DATE: 02.27.2019
TO: ProTrak
FROM: Bill McDow
Transportation Planning

■ **FLOW ACURA [TRC Pan Review]**

↻ Initial Review Note ↻

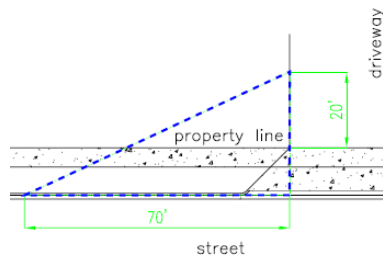
- ❖ The site has proposed an increase in Building size from the existing 7, 230 SF building to the proposed 17, 422 SF building, an increase of 10, 192 SF.
- ❖ Please provide the estimated trip generation for the new building, using the Land Use Code of 840 New Automobile Sales.
- ❖ Use a format that shows the estimated Trip Generation for the proposed **LUC 840 and 7230 SF for the Existing use and LUC 840 and 17, 422 SF for the proposed increase in usage**, (ite land use code 840) is xx total driveway volume in the AM peak hours, xx total driveway volume in the PM peak hours and xx average weekday 2-way driveway volume.
